AGENDA
City Planning Commission
September 23, 2026, 5:30 PM
Council Chambers – Hillsdale City Hall

VI. Consideration of Applications
- a. Commercial Site Plan Review – 8 E Bacon
- b. Commercial Site Plan Review – Hillsdale College Turf Building

Re: **Commercial Site Plan Review – 8 E Bacon St, Accessory Structure**

Re: **Preliminary Site Plan Review**

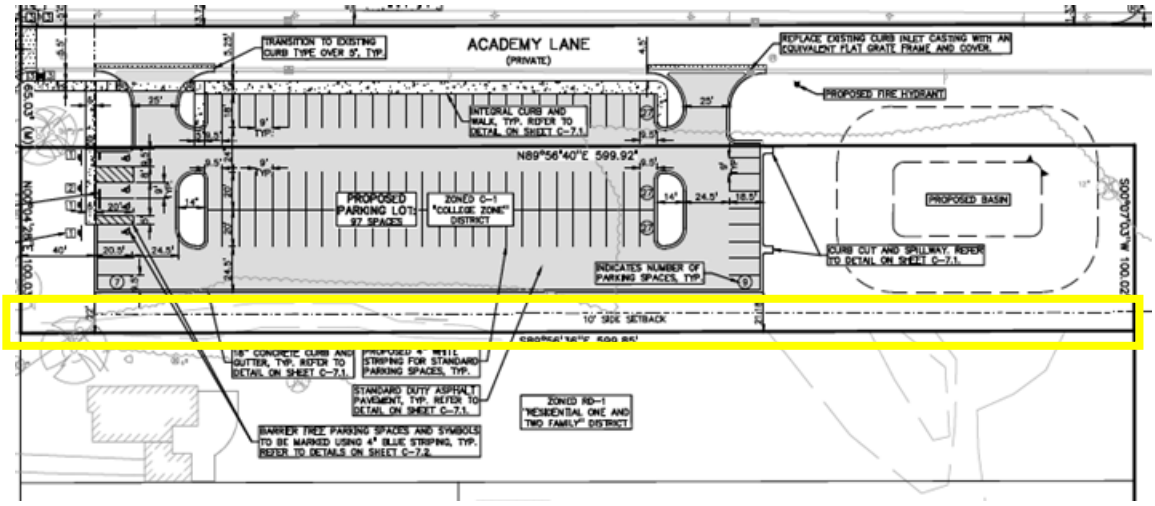
- Per Sec. 36-411(m), "A minimum four-foot-six-inch obscuring wall or fence shall be provided on those sides of the property abutting land zoned for residential use."
    - 171 Oak St, parcel adjacent to the south, (Parcel No. 30-006-123-376-05) is zoned RD-1 (One-Family and Two-Family Residential), as indicated on the site plan. Therefore, a 4'6" minimum fence or obscuring wall is required within the area highlighted on the site plan:

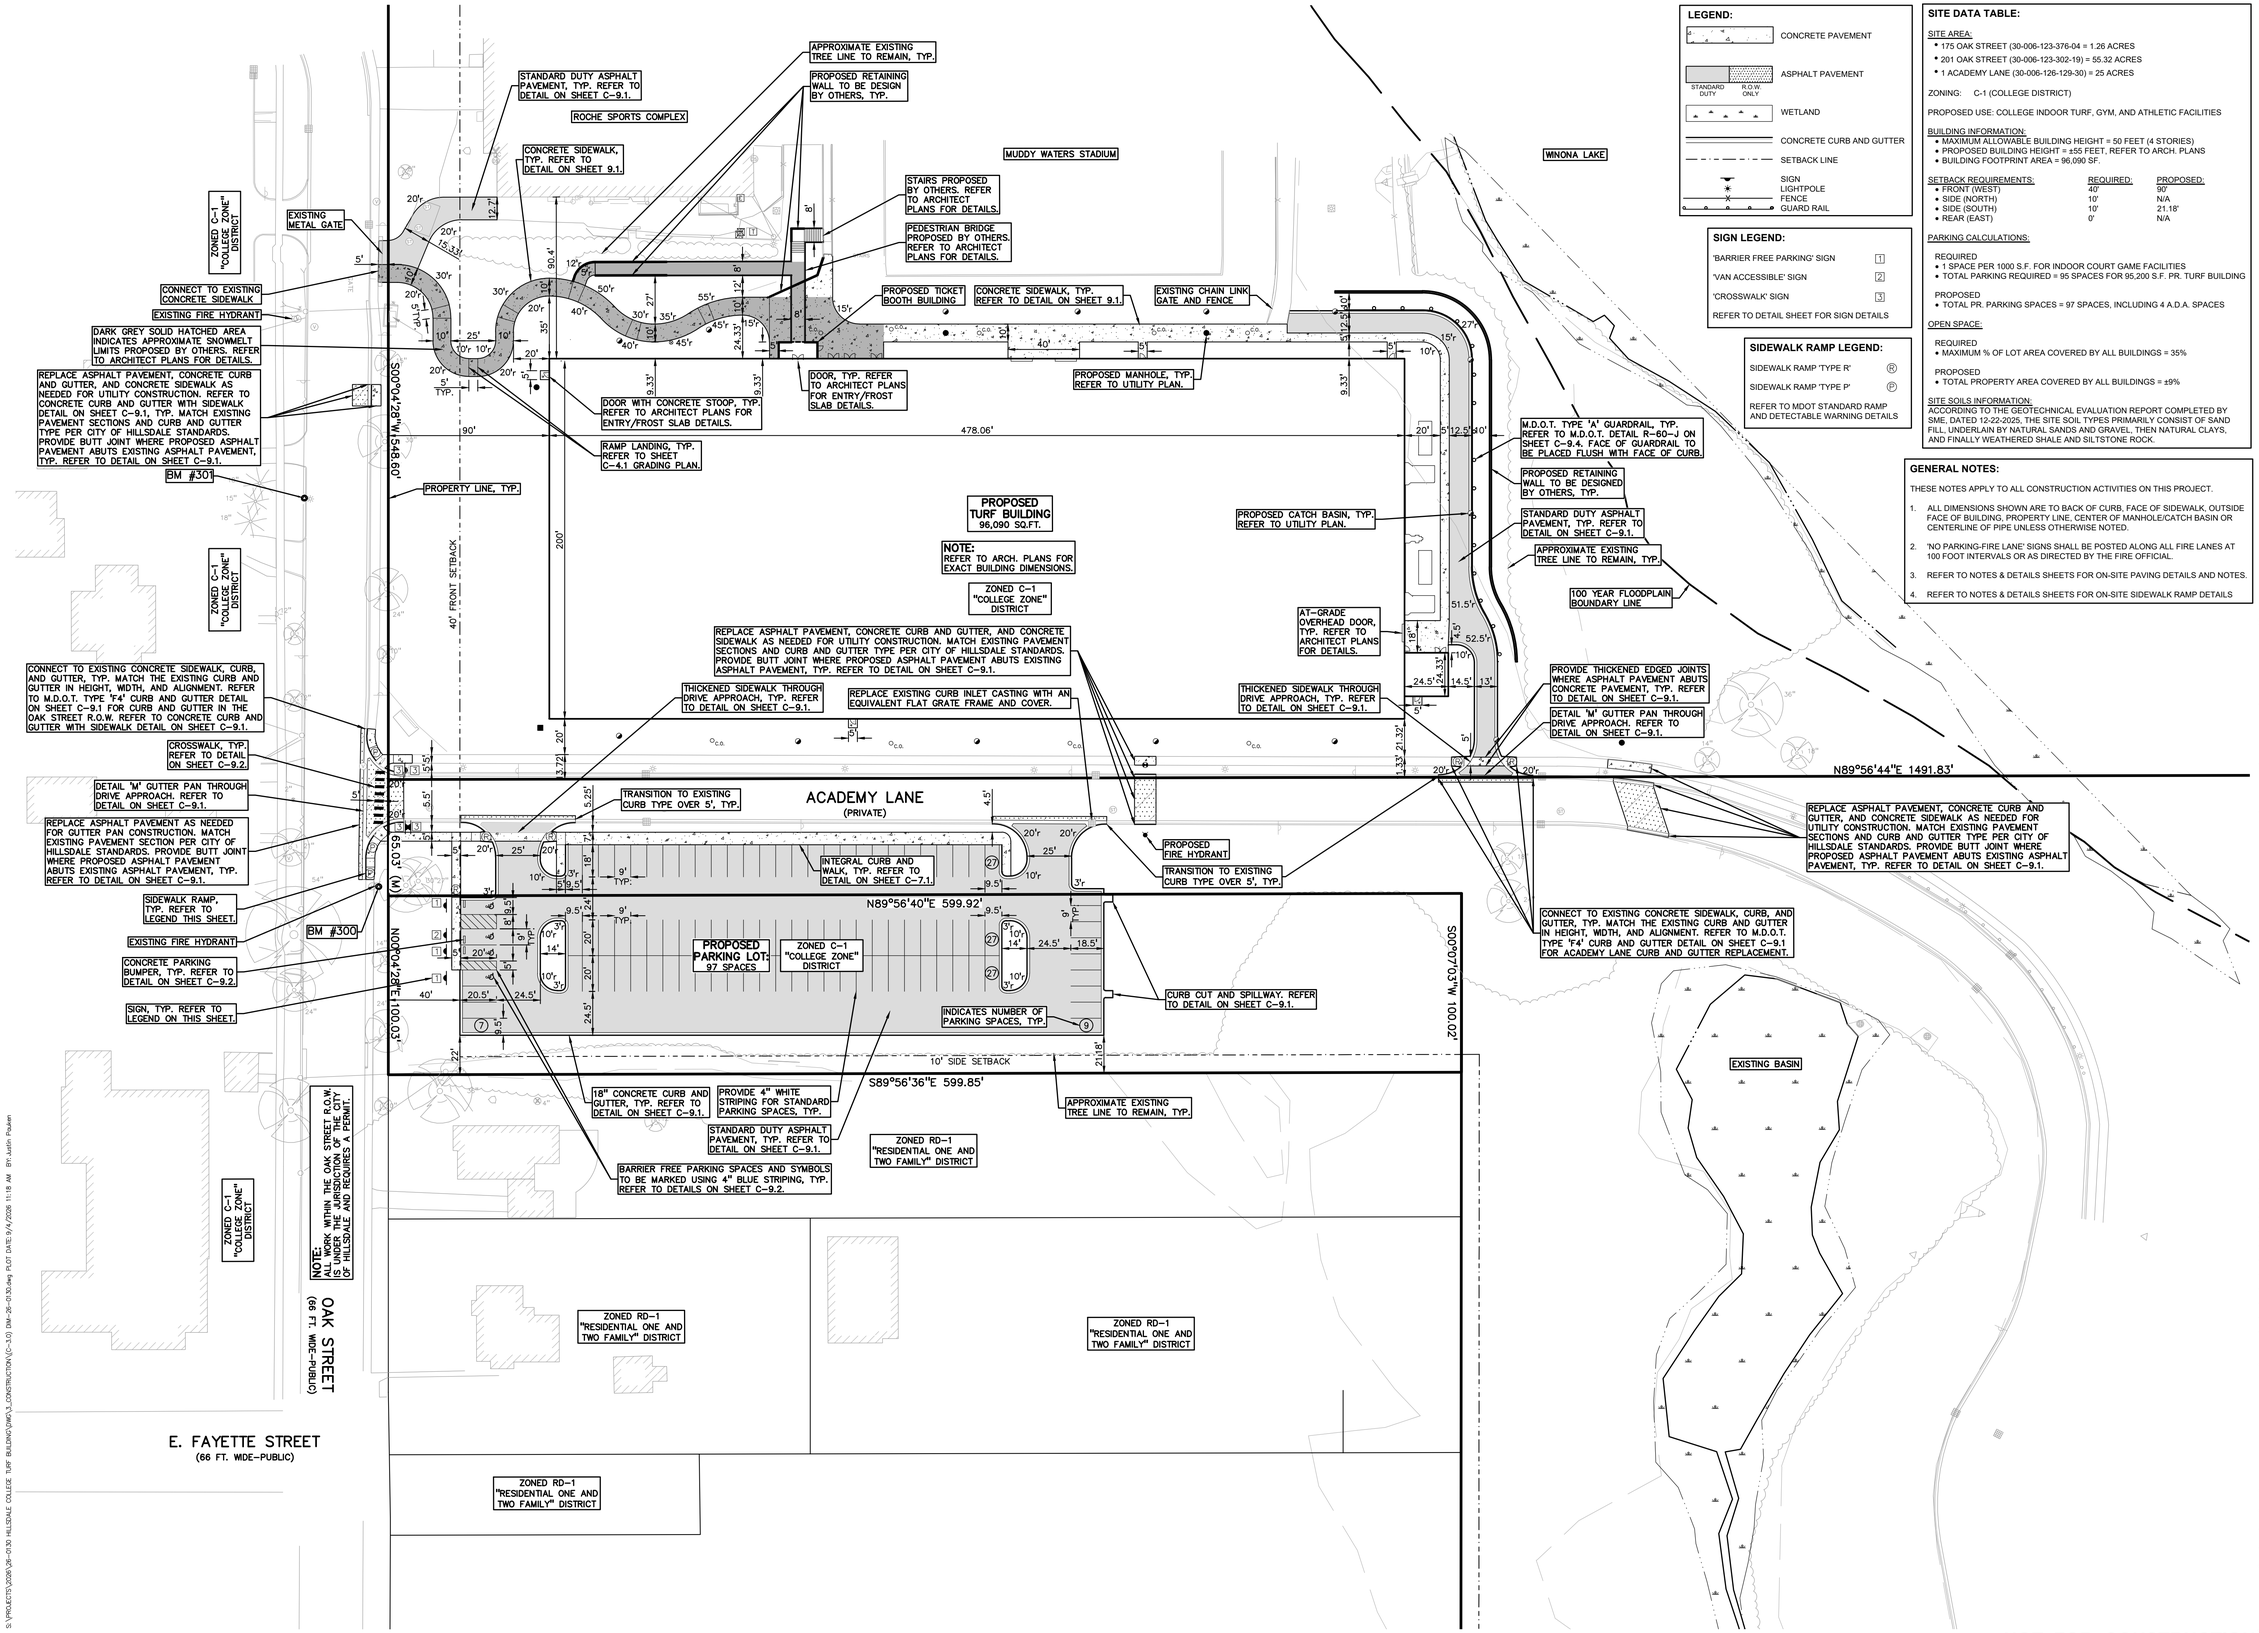
- C2.0 – Are the 4 existing courts being torn out or is the new building being built around them?
    - **Response: The existing courts will be removed. Refer to sheet C-2.0.**
- C2.0 – If the end turns on the track being torn out? If so, is a new track being constructed somewhere else?
    - **Response: Refer to sheet C-2.0 for track removal areas.**
- C.3 – The proposed parking lot crosses property lines. Parcel combination is recommended.
    - **Response: Acknowledged**

DRAWING NUMBER:
C-5.0

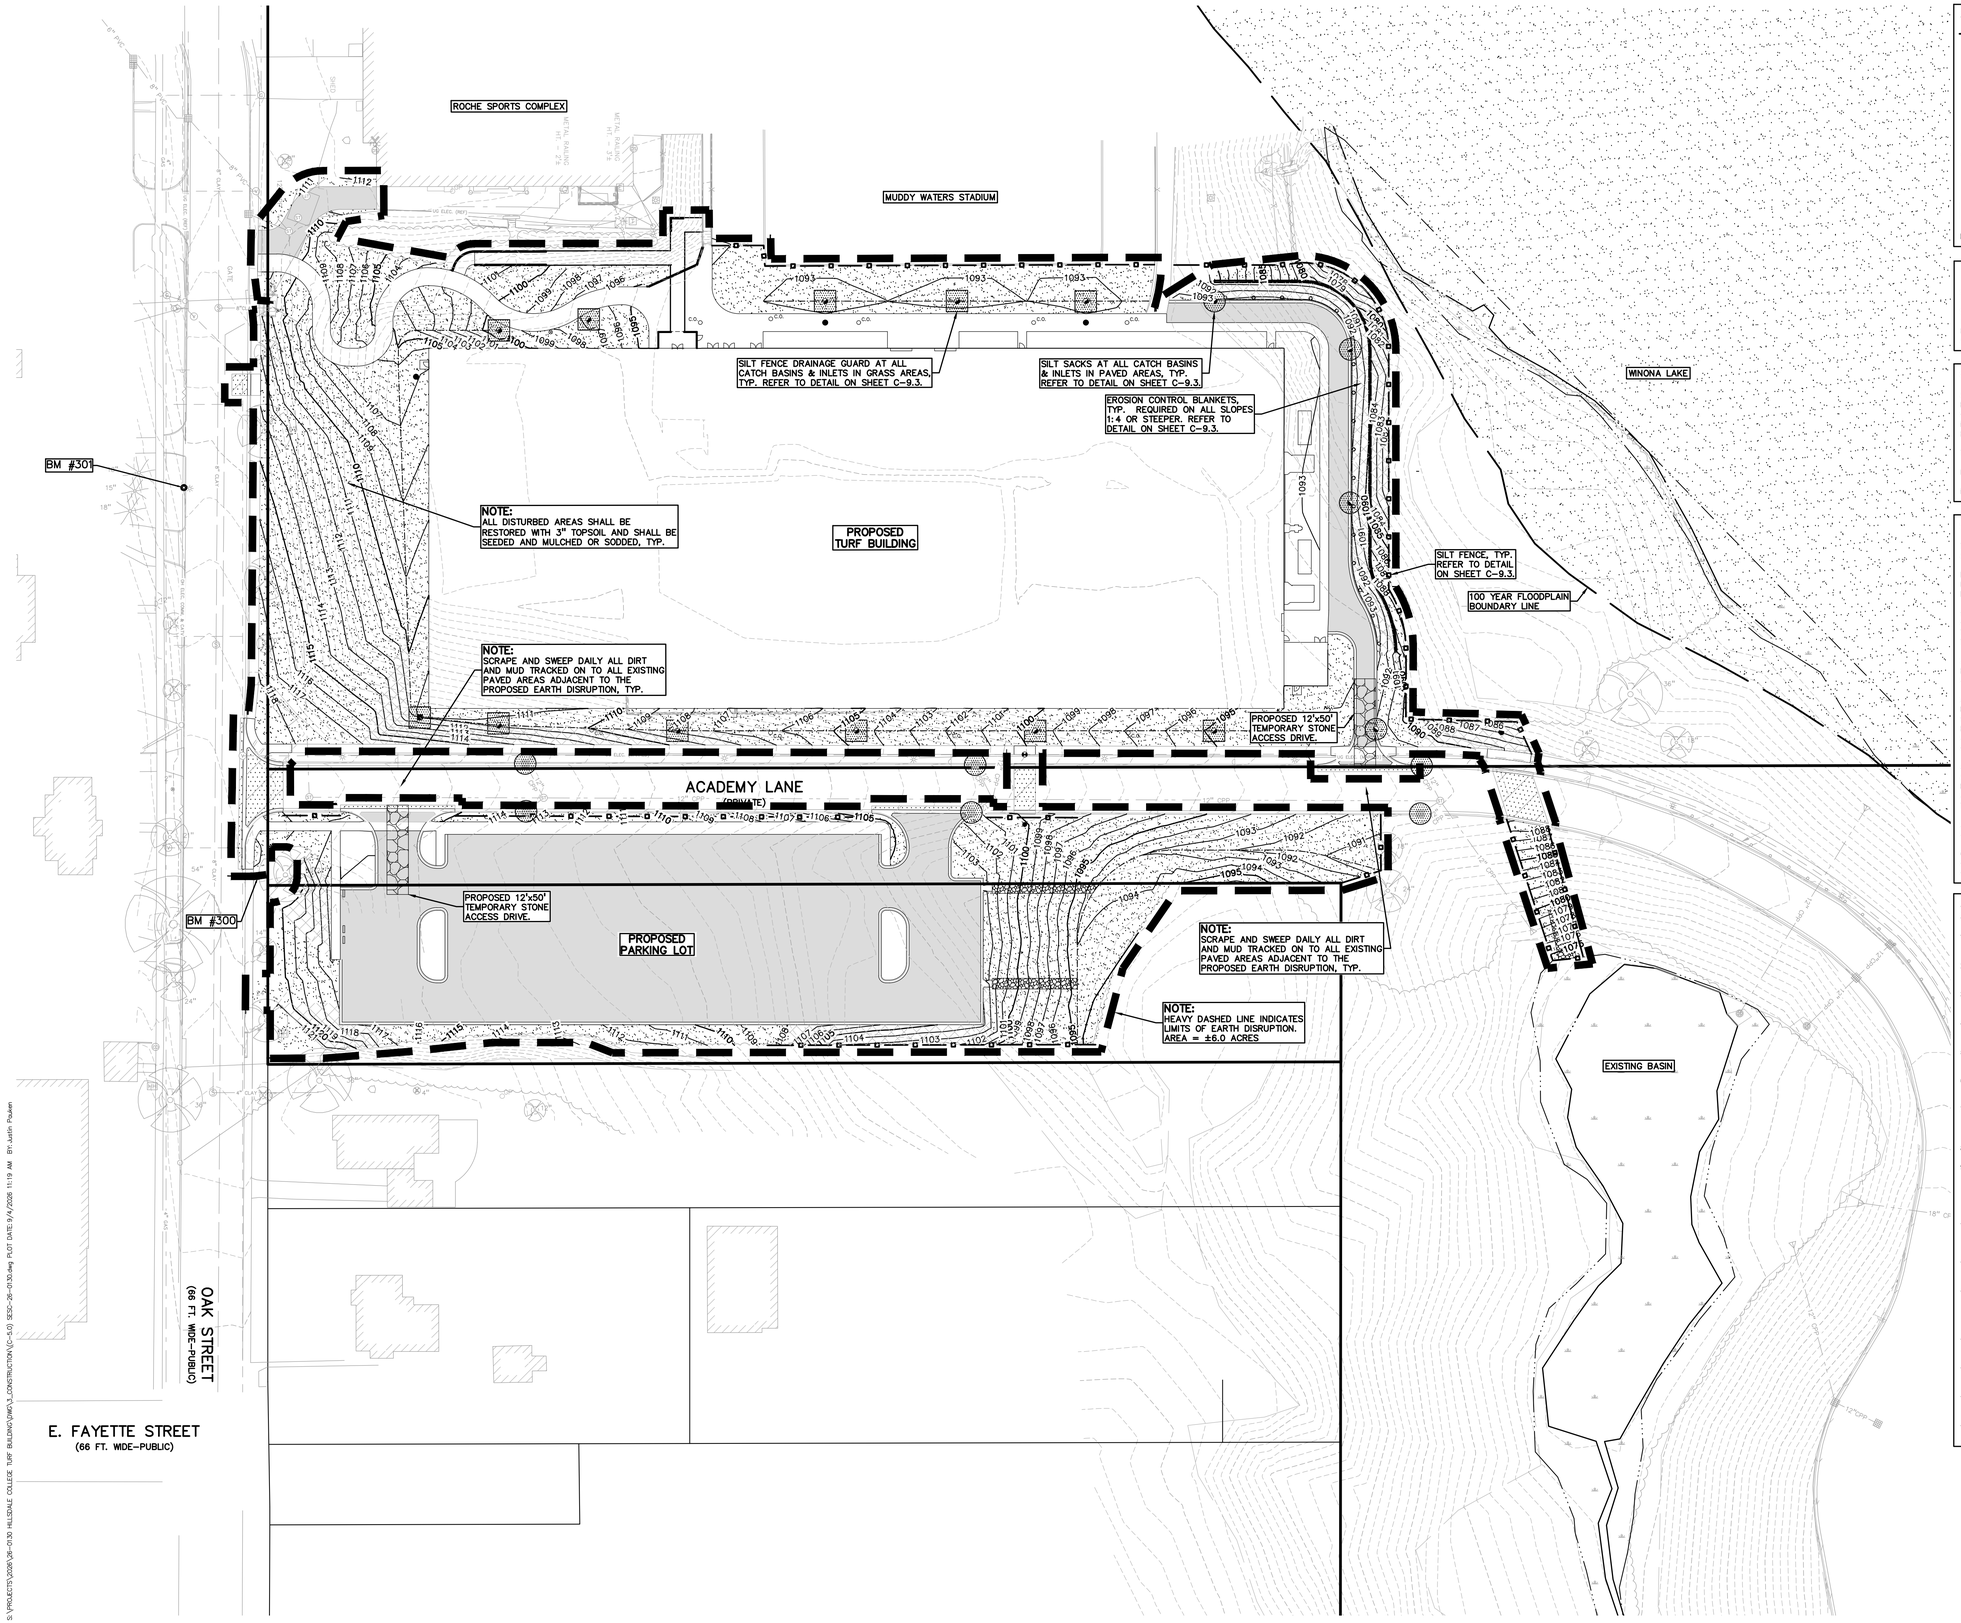
- **Response: Curb has been added to the drive and the grading has been revised. Refer to sheets C-3.0, C-4.3, and C-4.4 for revised design.**
- C5.0 – No reason to install silt fence at the top of hill, unless they are using it to define a work area.

- **Response: Refer to updated SESC Plan on sheet C-5.0.**
- C6.0 – The proposed gas service is shown conflicting with the CB in the proposed Drive on the East side of the proposed Turf Building, and I don't see the existing gas line that it is supposed to connect to. See note above about my recommendation to move the CB to a lawn area, but this comment is more for reference and should not be used to hold up approvals.

DRAWING NUMBER:
C-6.0

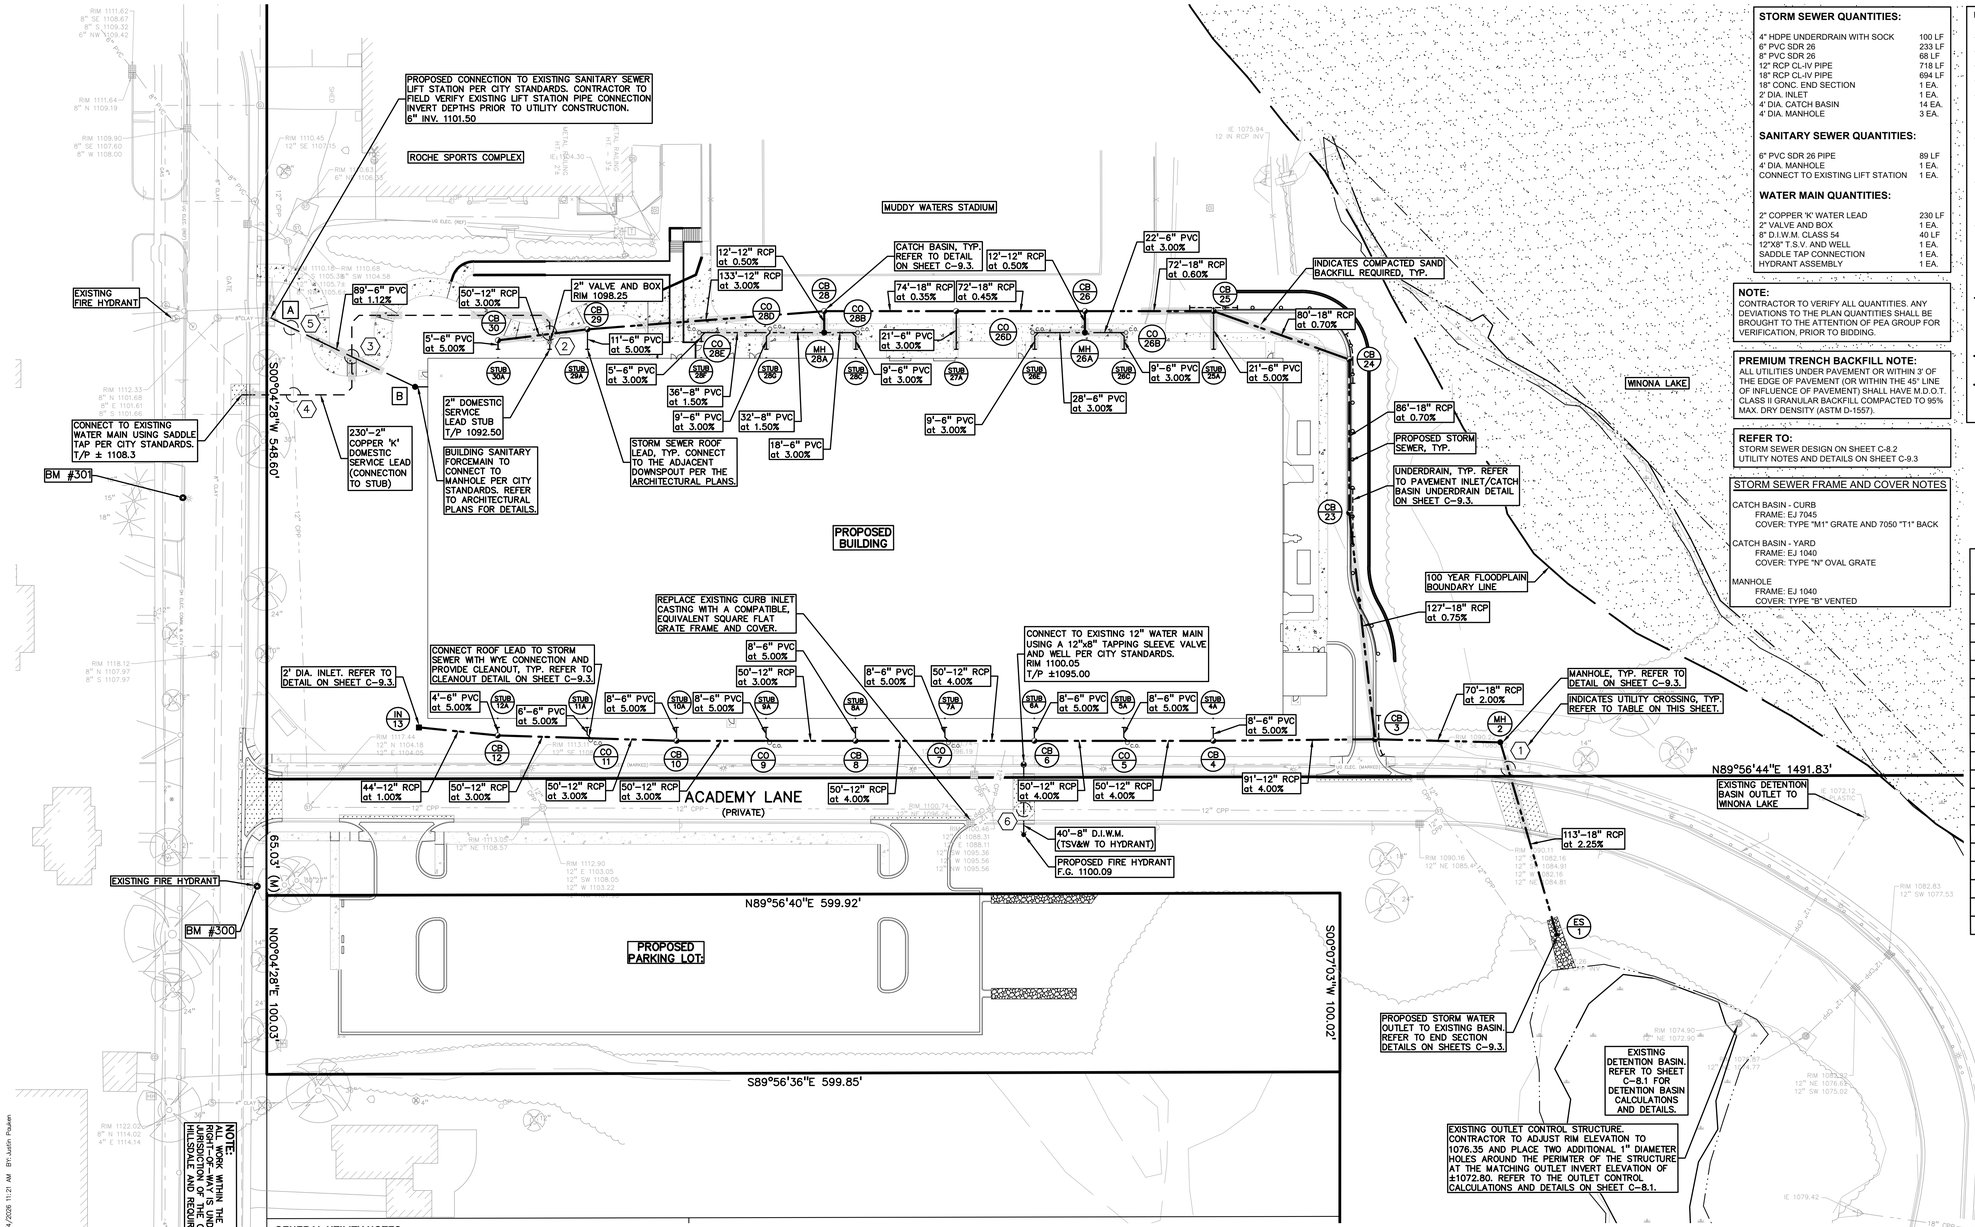
- **Response: Acknowledged. Refer to architectural plans for gas line locations.**
- C6.0 – Sanitary service is shown with a direct connection to the lift station. Recommend a connection to a sanitary sewer outside of the lift station as opposed to a direct connection. What is the size of the Sanitary Service?

- **Response: The layout of the proposed water service lead has been revised, refer to sheet C-6.0 Utility Plan.**
- C6.0 – Storm Sewer
    - There is summary of the Detention Volumes, but no calculations provide to show how the Volumes were determined.

- **Response: Refer to sheet C-8.1 for detention calculations.**
    - The detention basin is sized for the change for the site, but all the storm sewer on the north and east side of the proposed Turf Building, by-passes the detention basin.

- **Response: Proposed 6" dia. sanitary lead is proposed to gravity drain from the proposed manhole to the existing lift station to avoid additional impacts to Oak Street and crossing the existing sanitary forcemain, which would be required to connect to the proposed lead to the existing manhole in Oak Street. Refer to Utility Plan on sheet C-6.0.**

- **Response: Refer to sheet C-8.1 for detention calculations.**
    - No Pipe sizes or pipe materials are shown for the storm sewer.
        - **Response: Refer to sheet C-6.0 for pipe sizes and materials.**
